ADDENDUM 1

ADDENDUM DESCRIPTION: 470 270000261 Washington Unified School District Instruction to Service Providers and Low Voltage Upgrade-Rate Cabling 2027-28 Job Walk Clarifications and Notes

IDF behind the South Gym

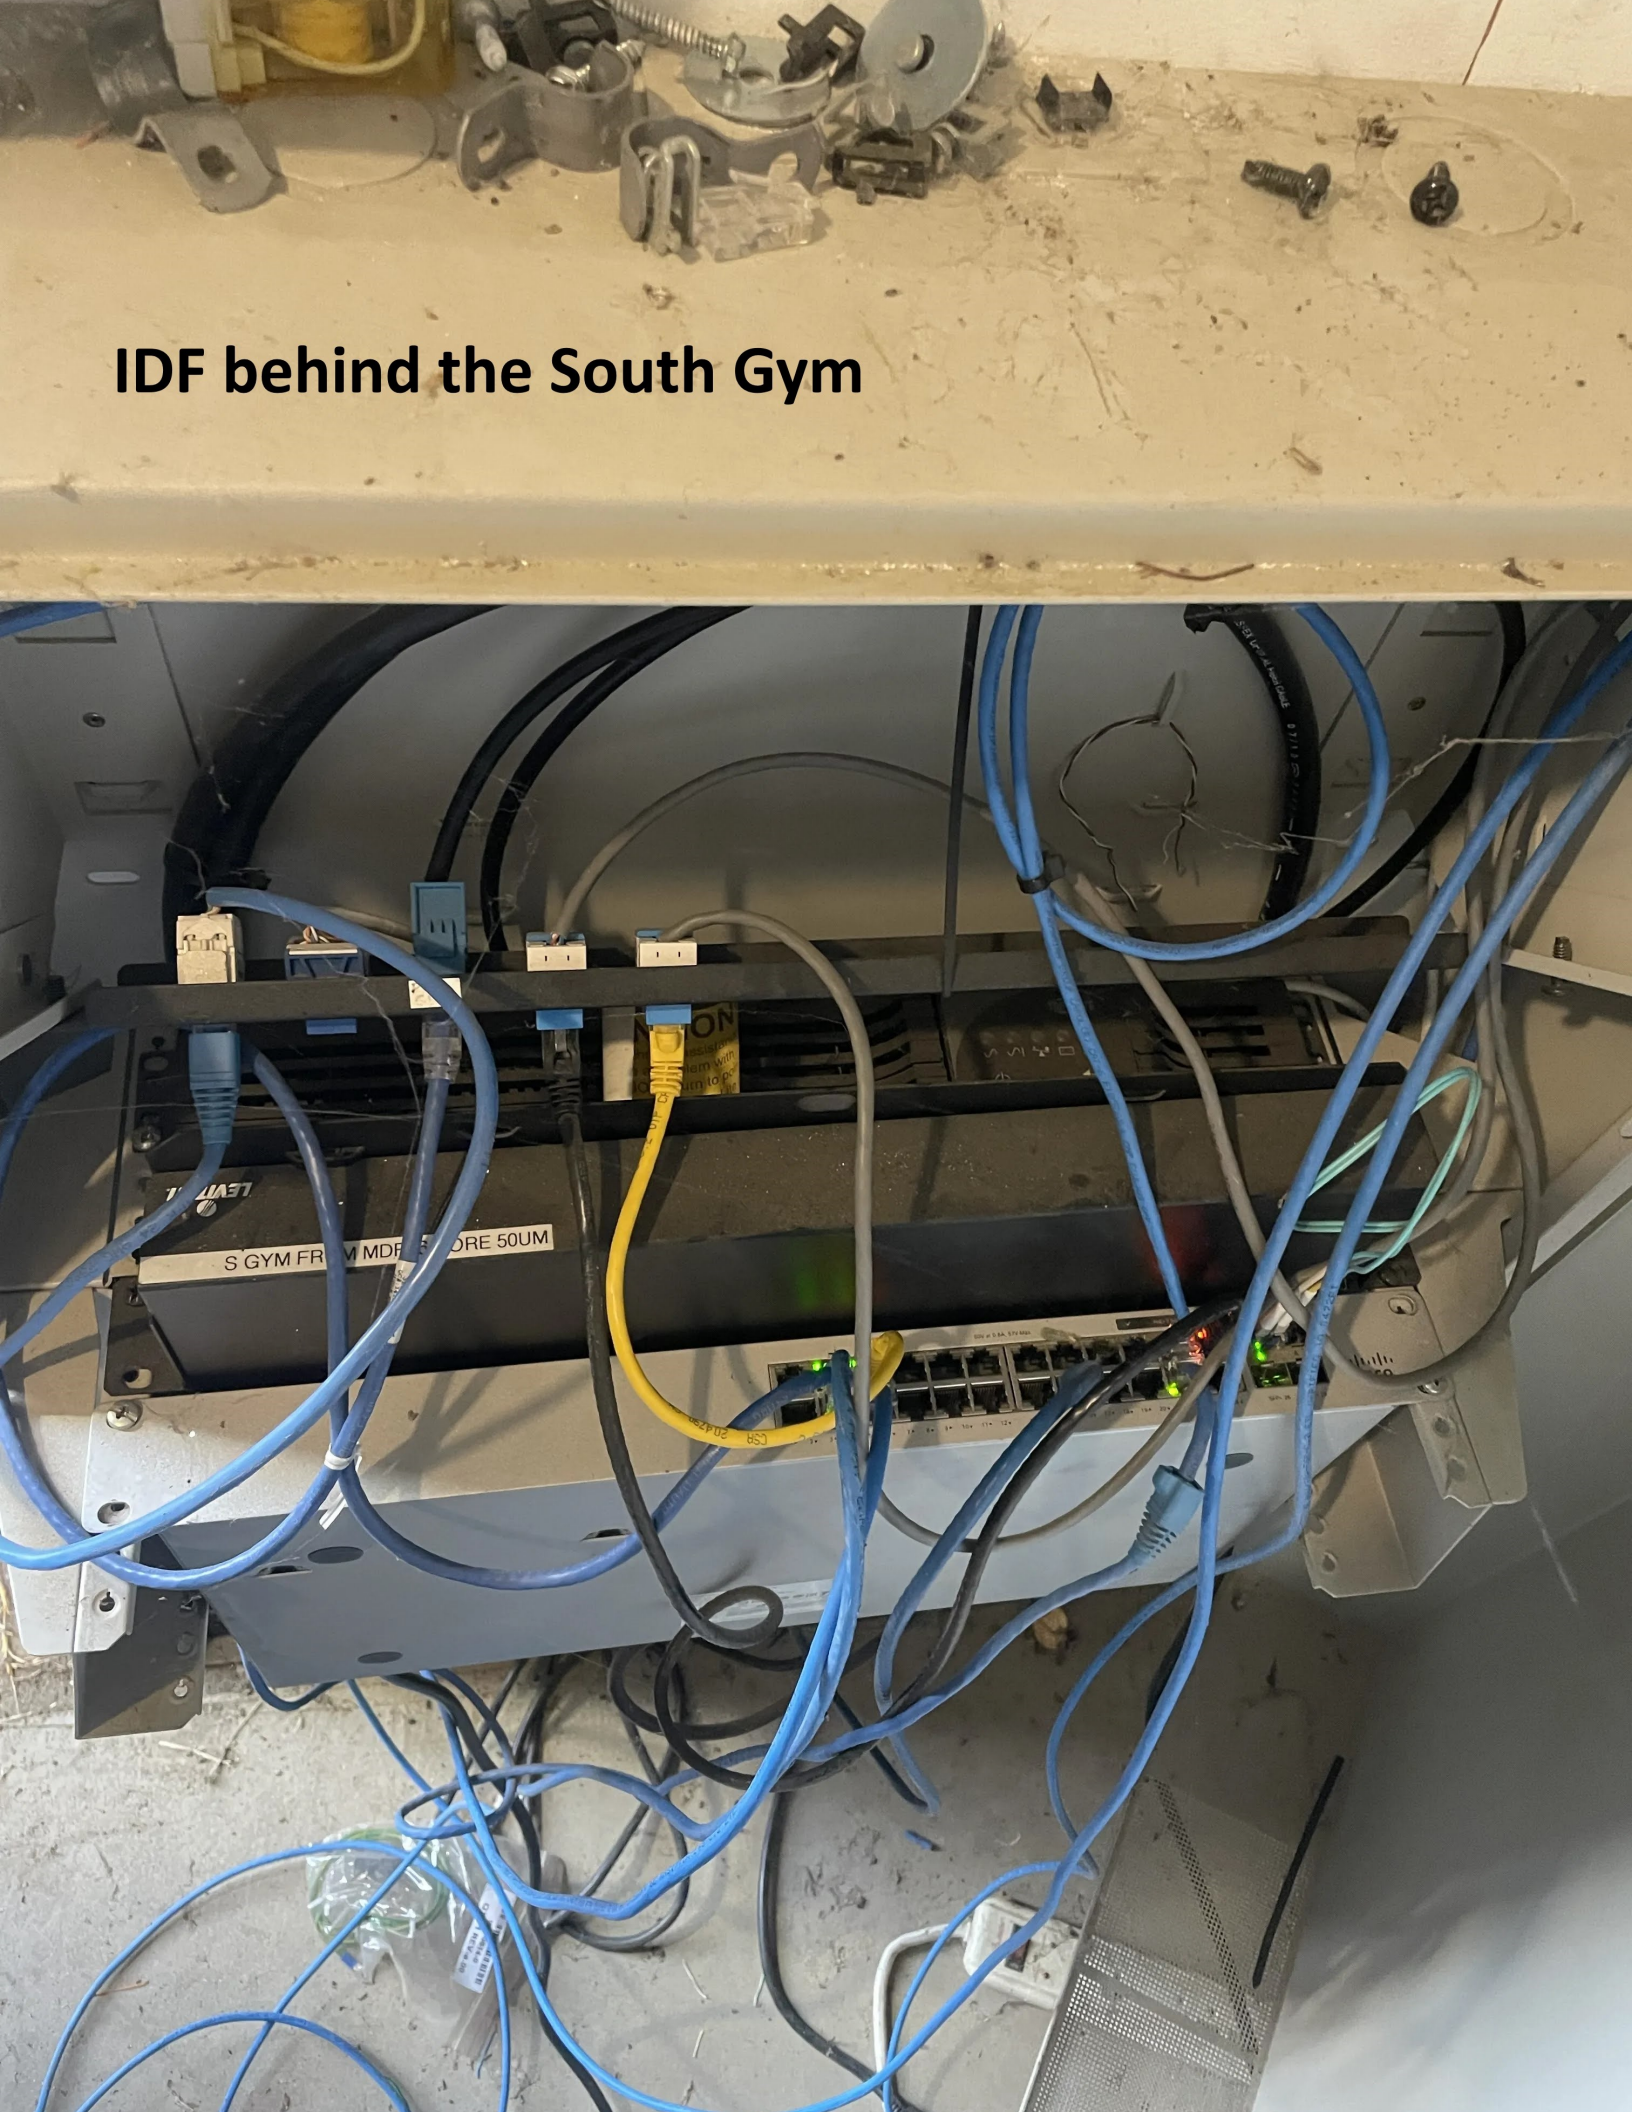
Photo #1: IDF behind the south gym

Stadium

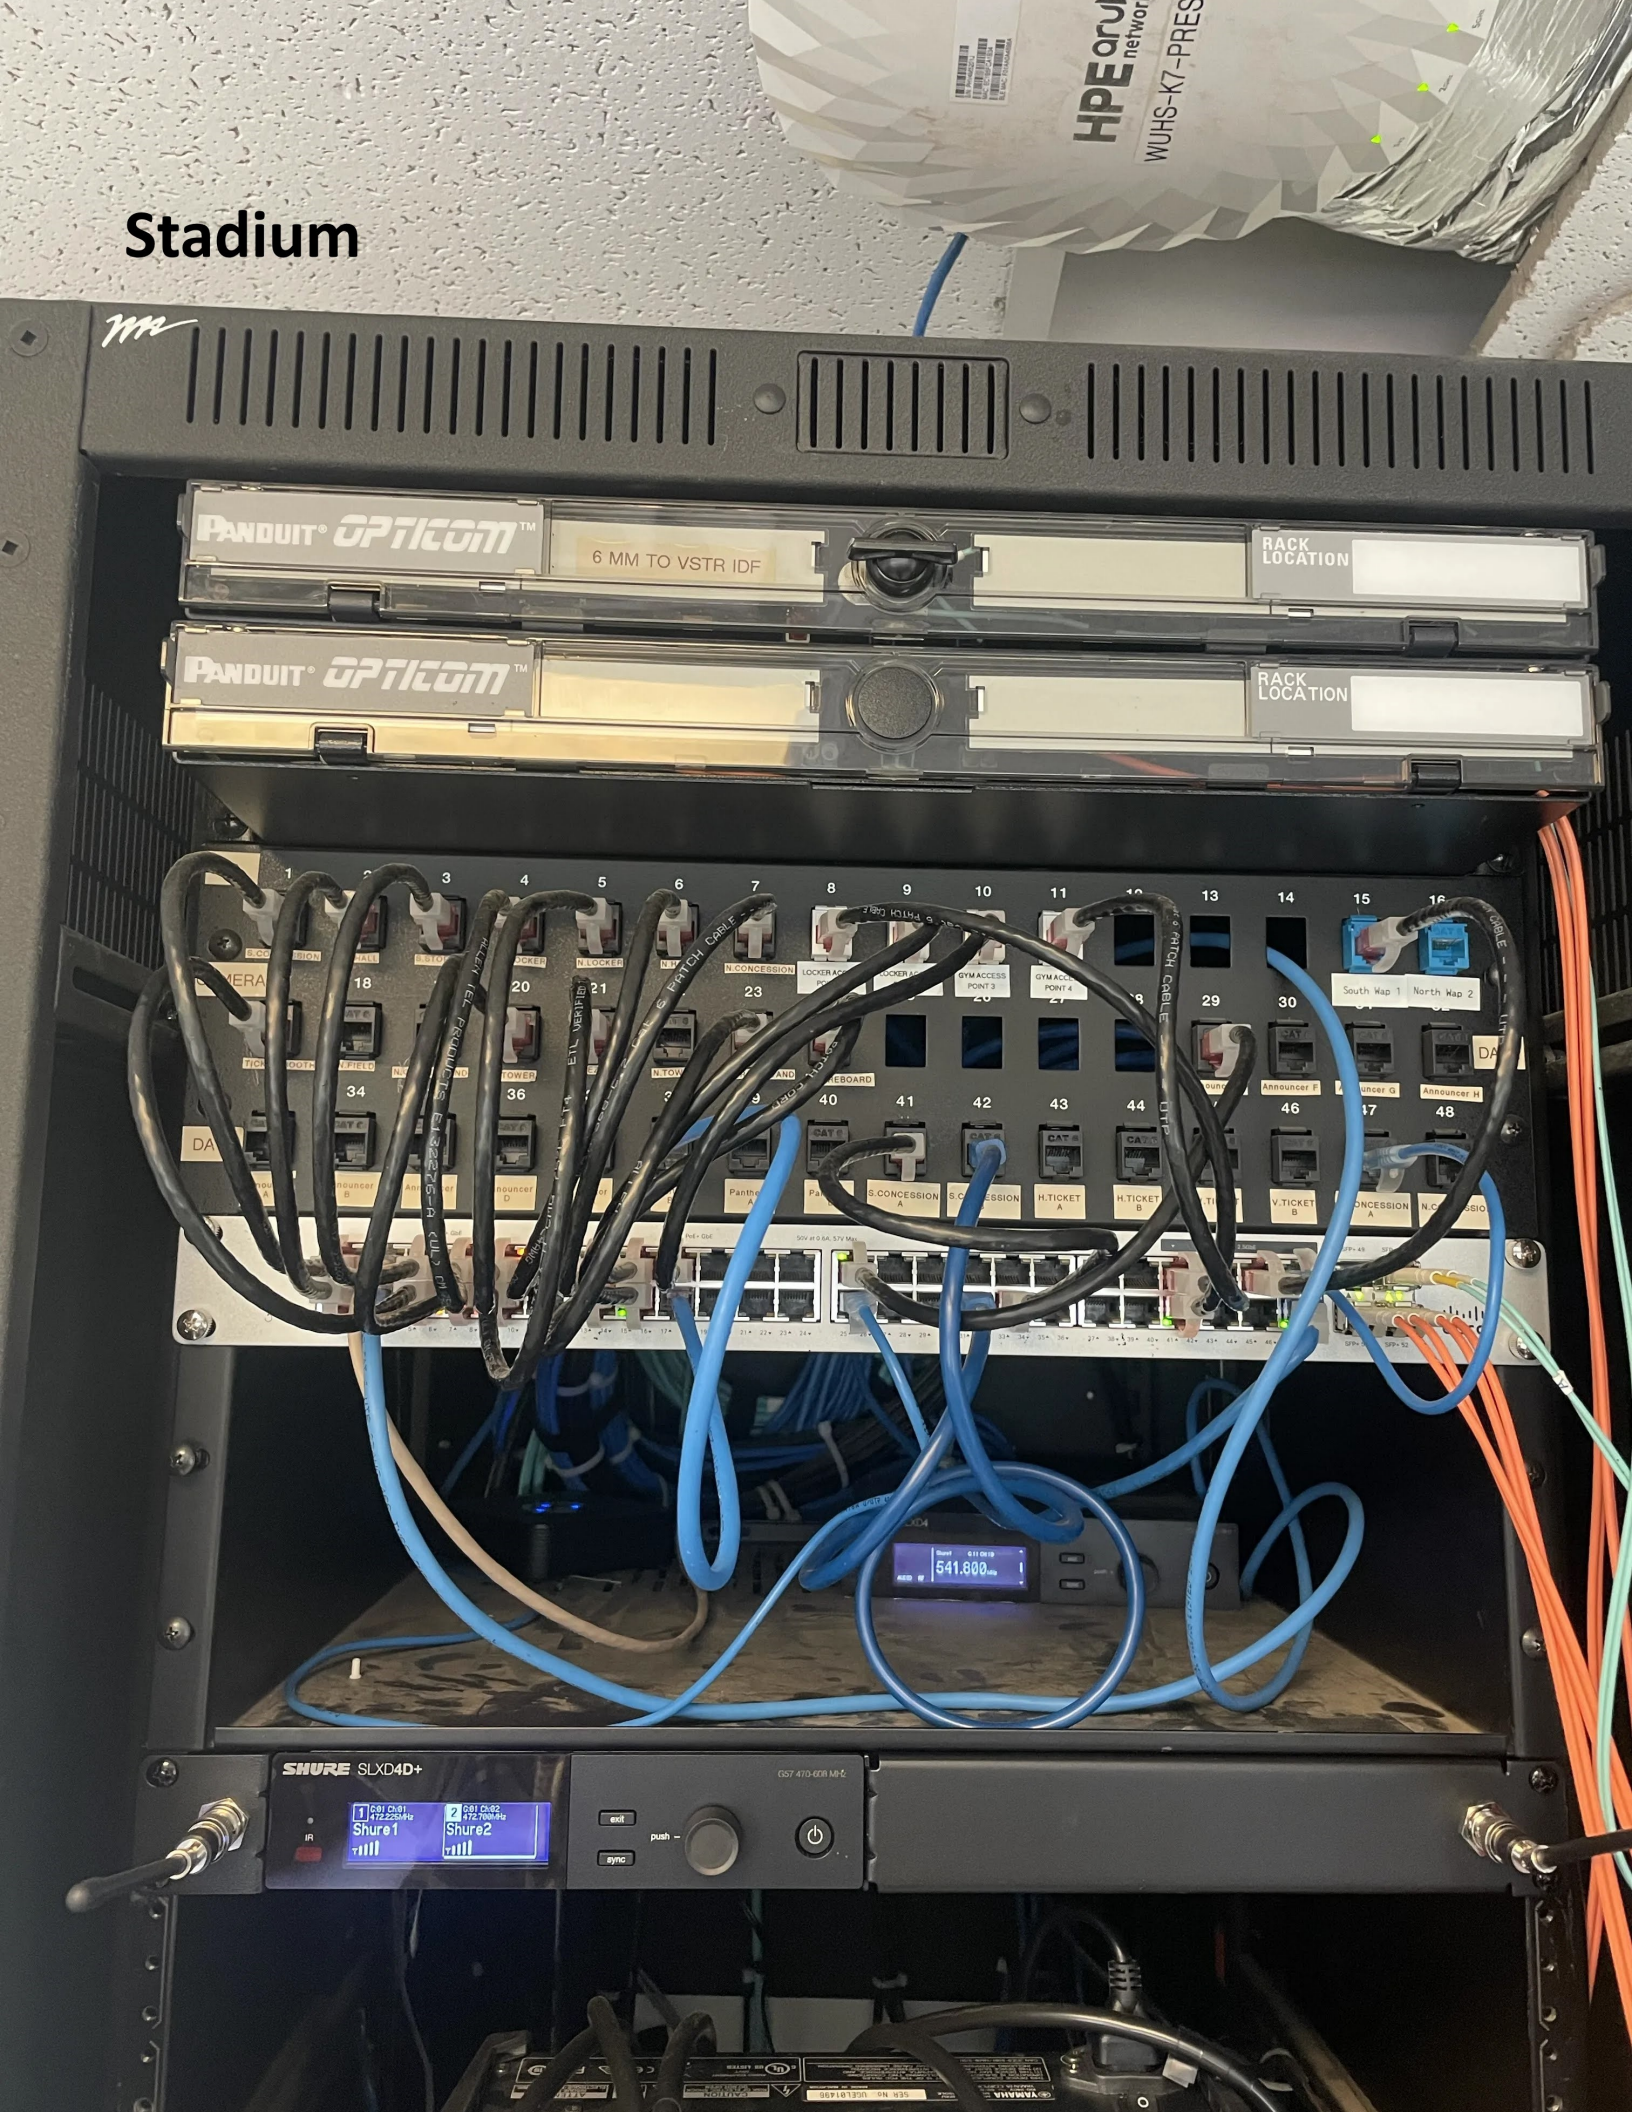
Photo #2: IDF at the stadium
